From: [REDACTED]
To: [REDACTED]
CC: [REDACTED]
Sent: [REDACTED]
Subject: RE: O8W-PM [REDACTED] - Bucks Creek 1101 Phase 1,2&3 -
Pre-Engineering Meeting
Attachments: Basemap Limits for PM's [REDACTED].kmz

Subject: O8W-PM [REDACTED] - Bucks Creek 1101 Phase 1,2&3 - Pre-Engineering Meeting

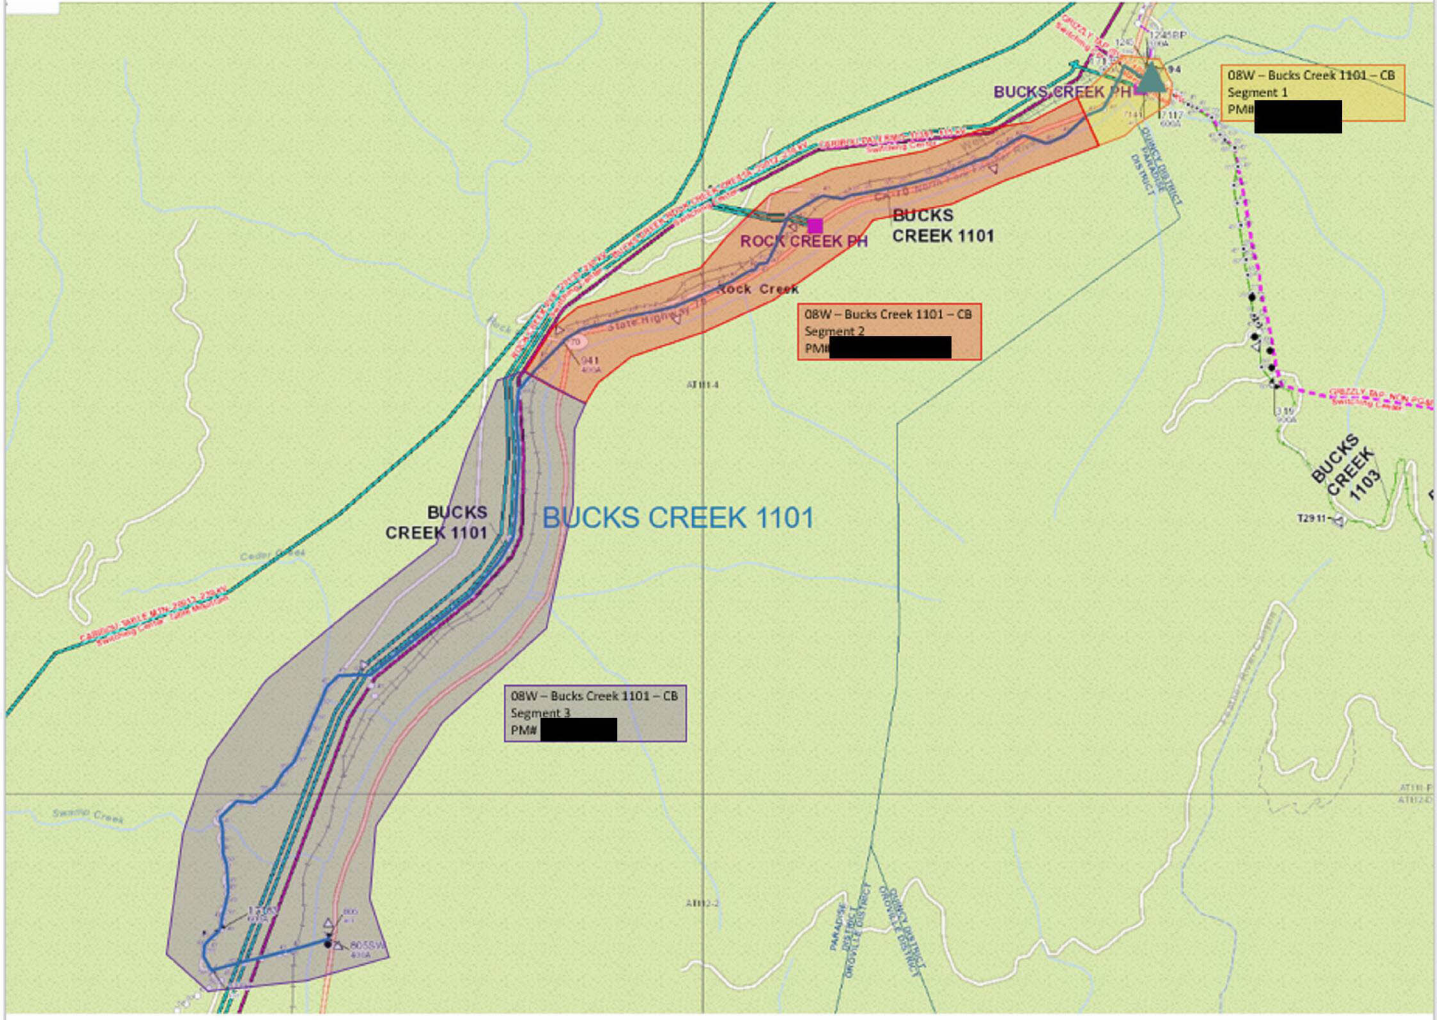
Attached are the 'base-map' limits in a kmz. file. As you will see, we need our base-map to go about ~100' into the tunnel at the south end (see pedestal in picture below...please begin about ~50 beyond this point which is about ~100' beyond the Cresta Dam.

We want to end the base-map at the sign location below which is roughly at MM (Mile Marker)
